**REMARKS/ARGUMENTS**

ANNOTATED SHEET SHOWING CHANGES

Title: STATOR DAMPER ANTI-ROTATION ASSEMBLY

Appl. No.: 10/002,594

FIG. 2

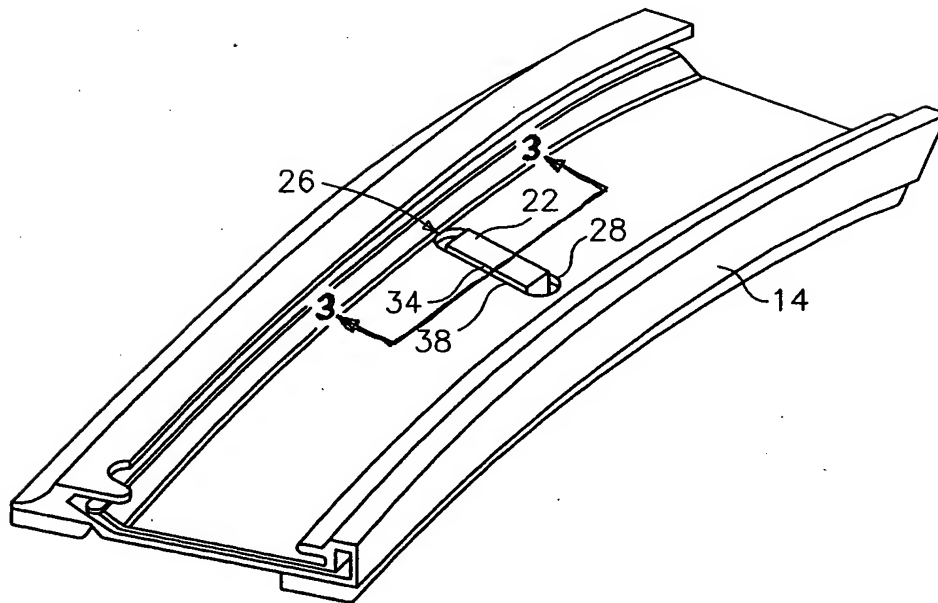
Attached to the instant paper are replacement sheets of drawings which include changes to Figs. 2 and 3. The sheets, which include Figs. 1-4, replace the original sheets including Figs. 1-4. Figures 2 and 3 have been amended to designate the brazing material of claim 12 by a reference number and to show the plane 3 - 3.

Also attached hereto are marked-up versions of the replacement sheets showing the changes in red.
